FUJITSU GENERAL AMERICA, INC 353 Route West. Fairfield, NJ 07004 Ph: 973-575-0381 Fx: 973-836-0449 Em: ServiceHVAC@fujitsugeneral.com	SERVICE BULLETIN Number: 0025 Date: 12/3/2012 TYPE: Field

PROBLEM:	**Evaporator intake grille may not completely close.**
SOLUTION:	Add an adhesive tape to make intake grille clip fit tighter making sure panel snaps completely closed.

MODEL : **ASU- 9-12-15RLS2**	PART NUMBER: **KCLIPRLS2**

Fig. 1

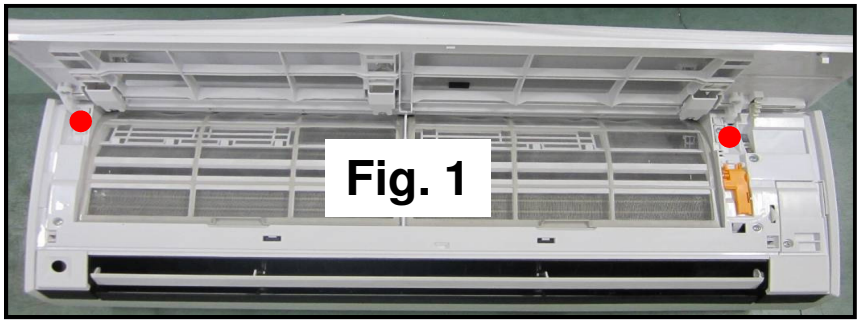
1. Remove the Intake grille.

Fig. 2

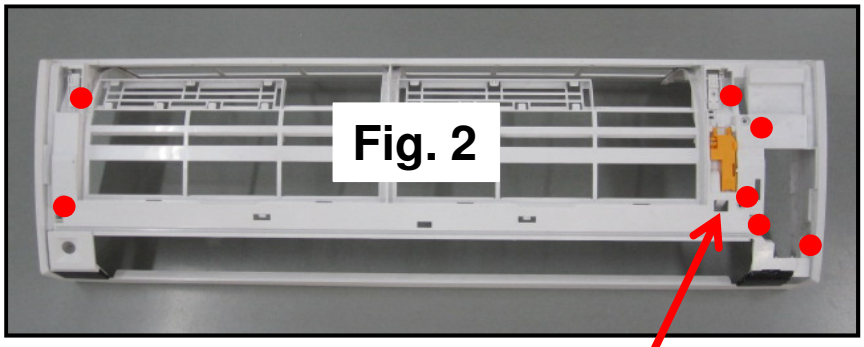
2. The **red** circles indicate the screws that need to be removed to dismount the evaporator cover.

3. Remove the front panel cover screws. Proceed to remove entire cover from evaporator.

Fig. 3

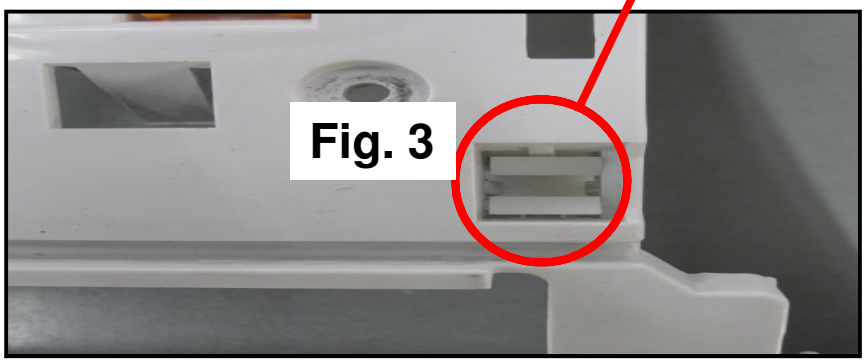
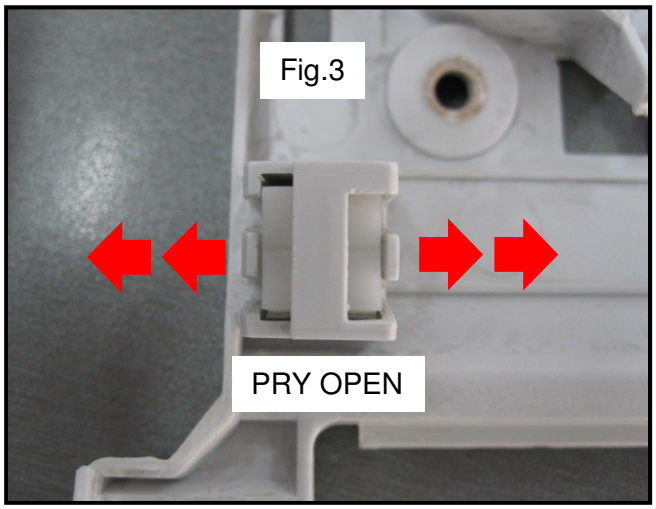
4. This (1) clip needs to be removed, located on the right side (front) cover.

Turn to the back of the evaporator cover and find where the clip is inserted (figure 3). ***Carefully pry open*** the 2 snap arms outward (follow the direction of the **red** arrows) then push clip out.

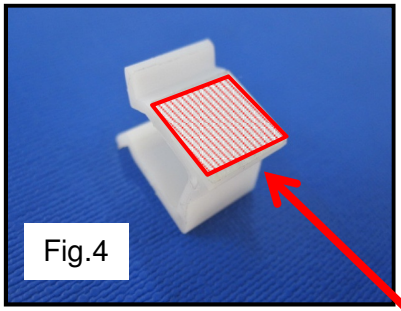
Attach the adhesive modification sheet in (fig 4) to either side of the clip.

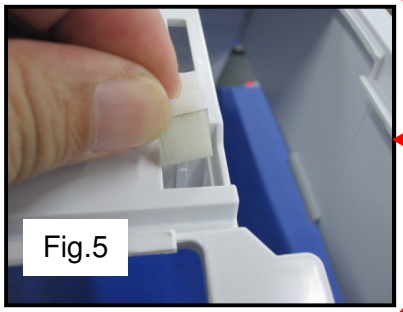
Reinserted clip back into its locations with the adhesive sheet facing downward. (fig 5)

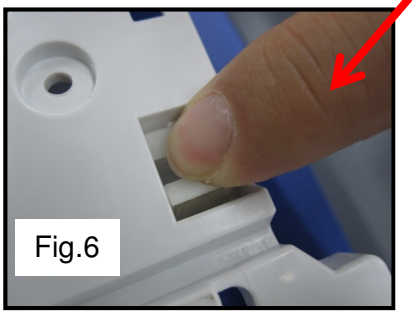
Make sure the clip is completely snapped-in by listening for the snapping sounds. (fig 6)

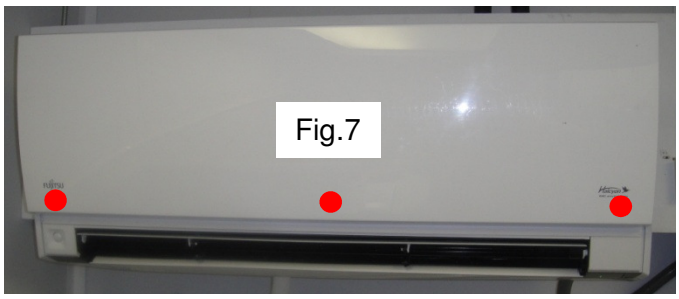
Close the intake grille and listen for the snapping sound to confirm that it is snapped-in along the 3 locations of the front cover as shown in Fig 7. The **red** circles indicate where the front cover should be snapped into intake grille.
